Cambourne to Cambridge: In-Highway Proposals for High Quality Public Transport Scheme

*Produced for Cambridge Past, Present & Future
by Edward Leigh MA MSc, February 2021*

Figure 8: Whole-day (14 June 2017) traffic flow inbound on Madingley Rd and joining the M11 at Junction 13 (from NR page 8)

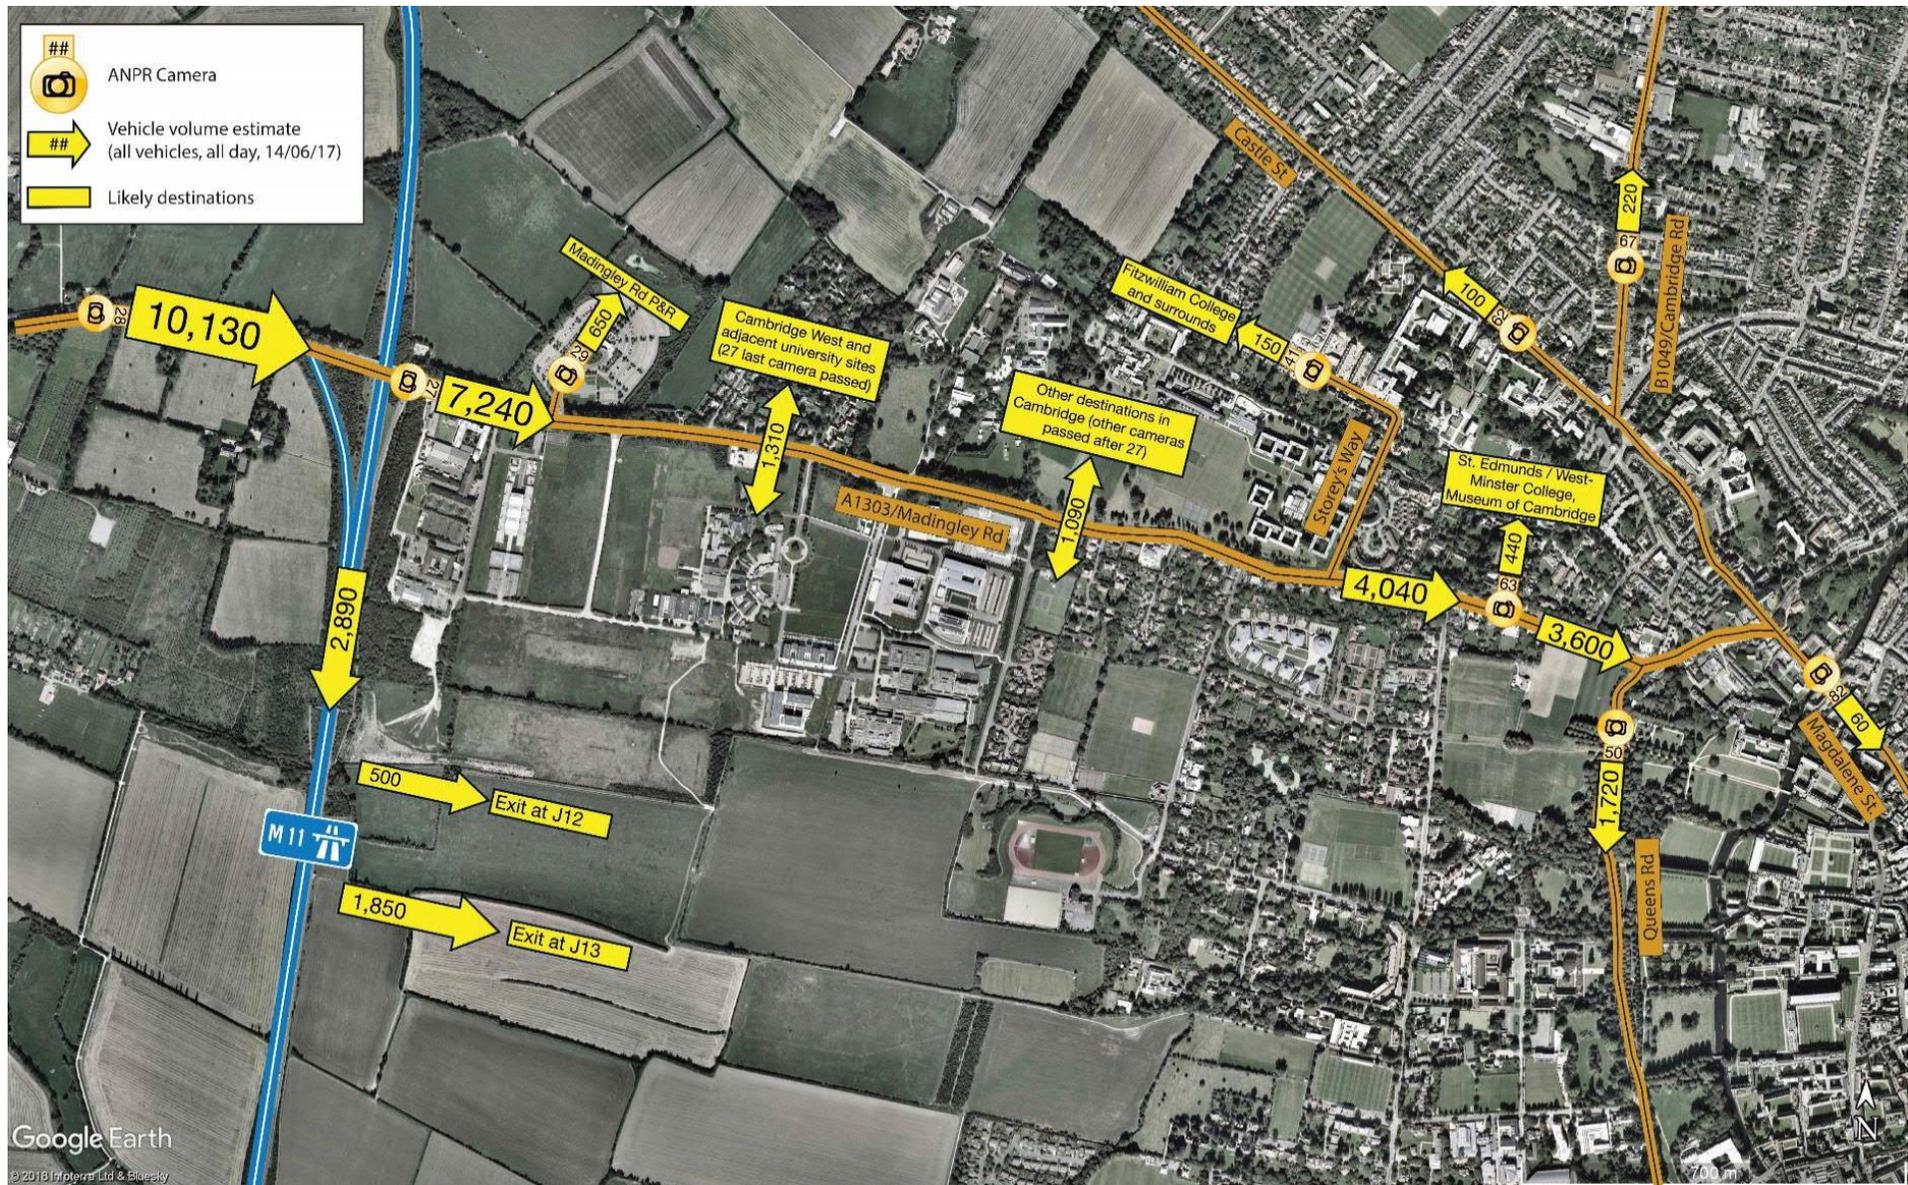
ANPR data gathered in June 2017 showed that 30% of inbound traffic on Madingley Hill turns onto the M11 at Junction 13 (see Figure 8 and NR2.16).

Figure 10: Changes proposed to A1303 at M11 junction as part of Bourn Airfield planning application (S/3440/18/OL)

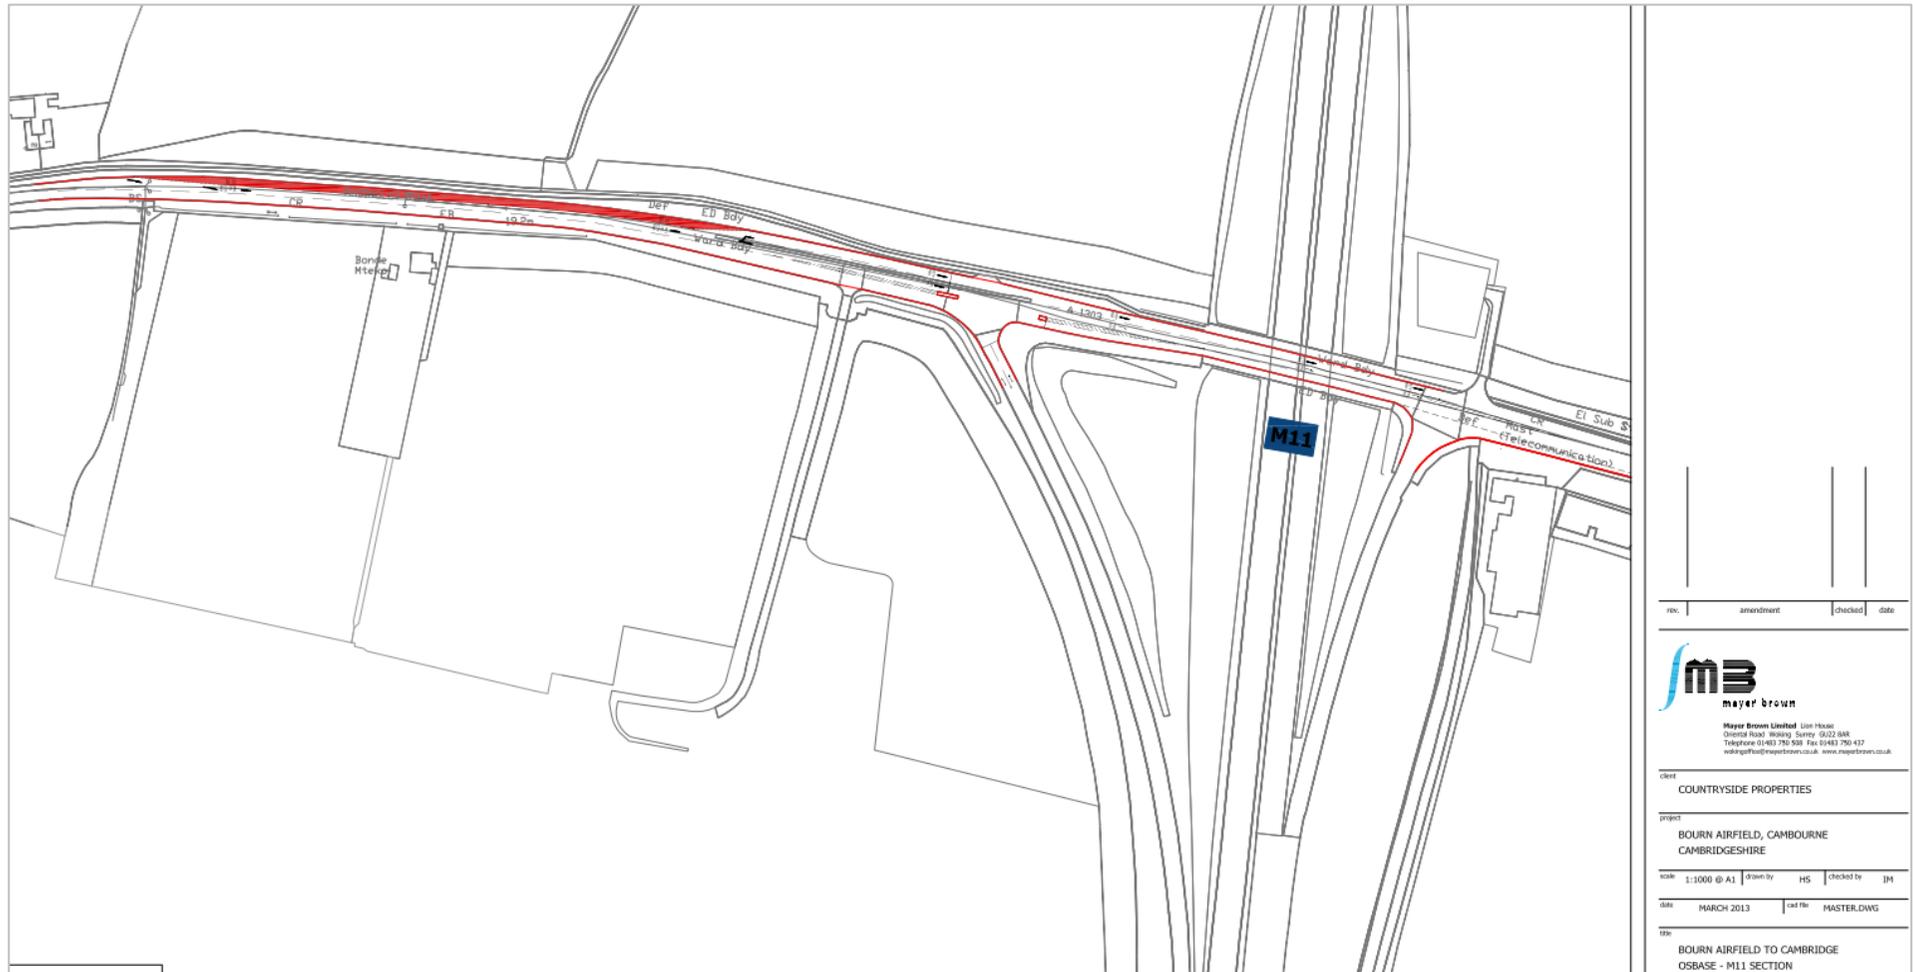
Note that the planning application for Bourn Airfield (S/3440/18/OL) includes a similar proposal to segregate M11-bound traffic from city-bound traffic (see Figure 10). Both options should be modelled with accurate peak-time traffic volumes to determine which benefits buses more.

Figure 13: Westbound bus lane into Madingley Mulch roundabout (from QW 3.1/Mott MacDonald)

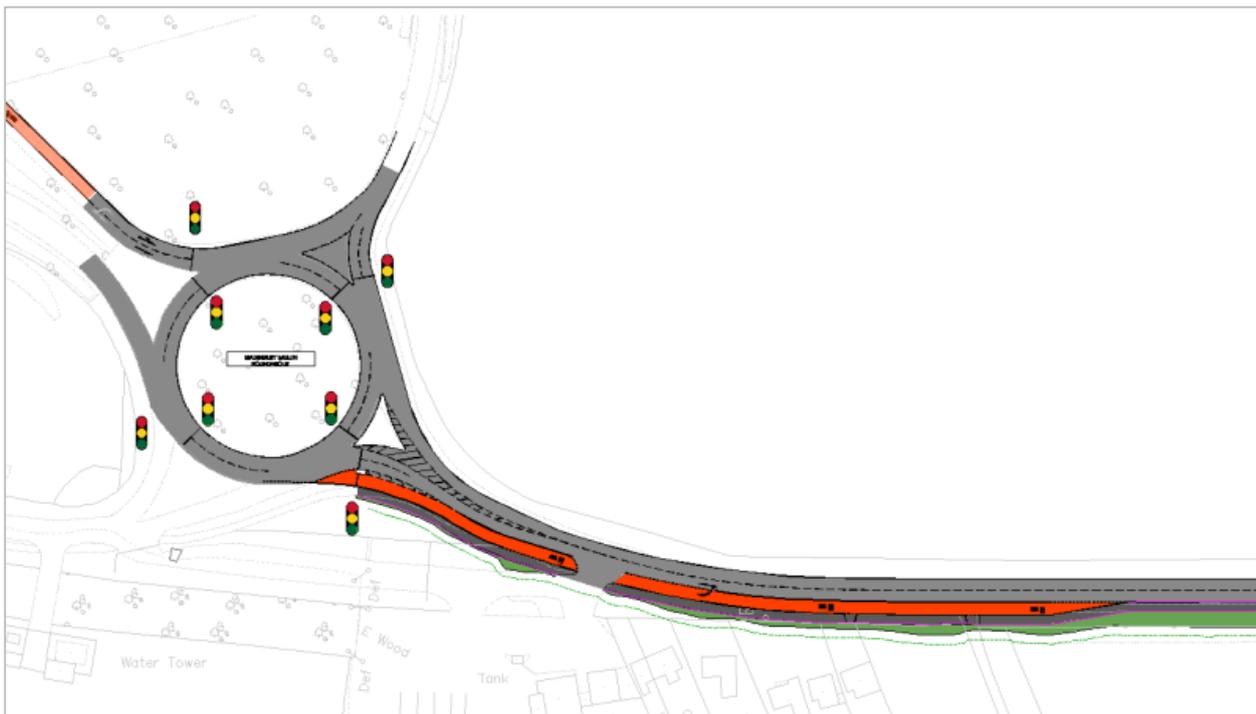
3e. Outbound bus lane: A westbound nearside bus lane could be accommodated within highway land to the south of Madingley Mulch roundabout (see Figure 12). This would provide buses with a congestion-free route if and when a queue builds on the approach to the roundabout (see Figure 13). (Reviewed in QW3.1.)

Figure 14: Four-lane configuration of M11 “Rectory Farm” bridge (from RFB page 33 © 2016 Atkins Ltd)

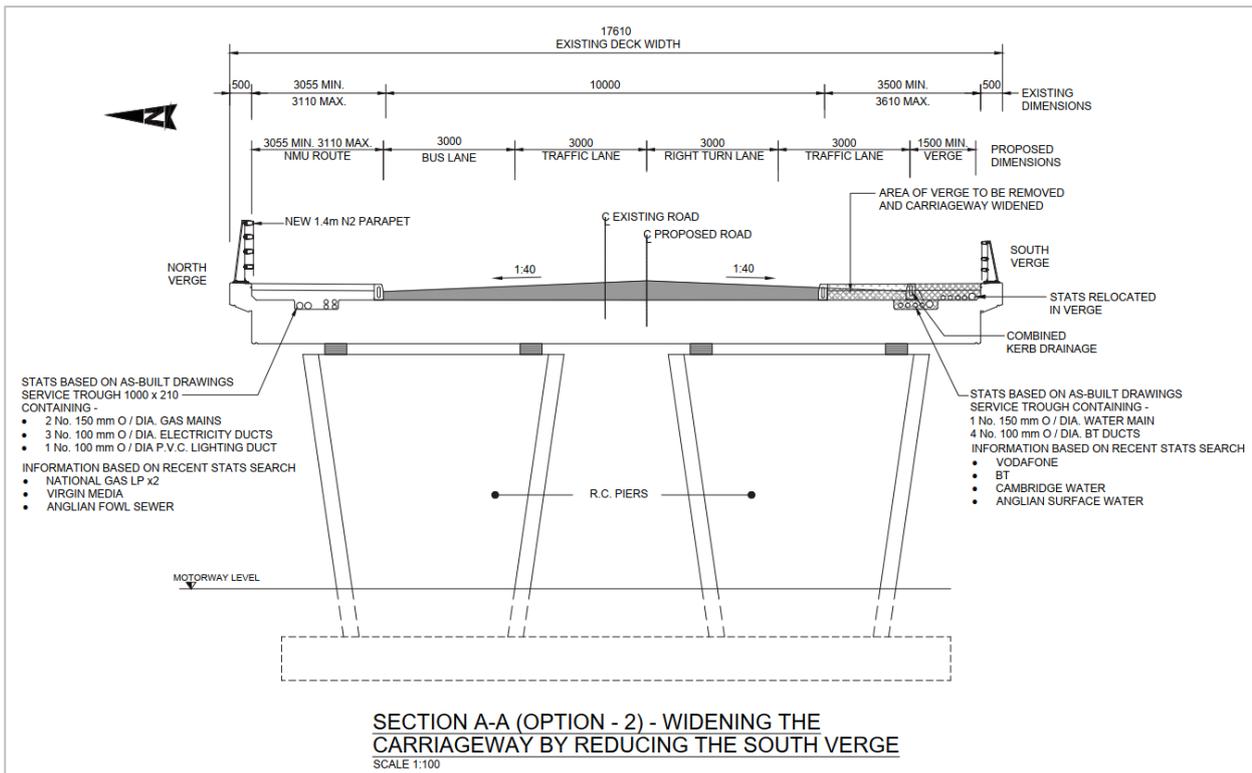
3c. Bus lane (not recommended): Although RFB details in Option 2 (see Figure 14) how the bridge can accommodate four 3m-wide traffic lanes in addition to the existing NMU lane, the gain is relatively small once the filter lane is extended beyond behind the end of the existing bus lane (1a).

Figure 20: Reassignment of hatched outside lane on A428 at the Girton Interchange to create a 640m long bus and coach lane

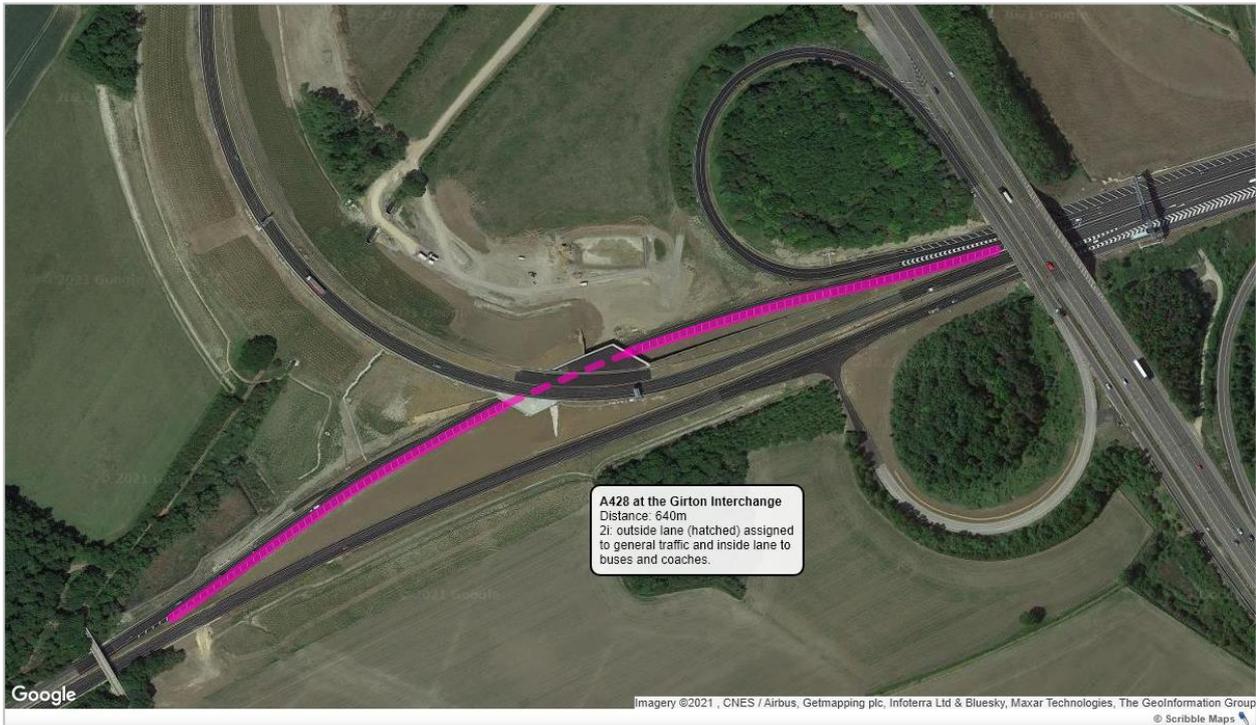
2j. Reassign hatched carriageway on A428: Moving the general traffic lane into the offside hatched area would free up the inside lane to be used by buses and coaches (and emergency vehicles). If the lanes merge before the M11 overbridge, this would provide a 640m bus lane to bypass congestion (see Figure 20).
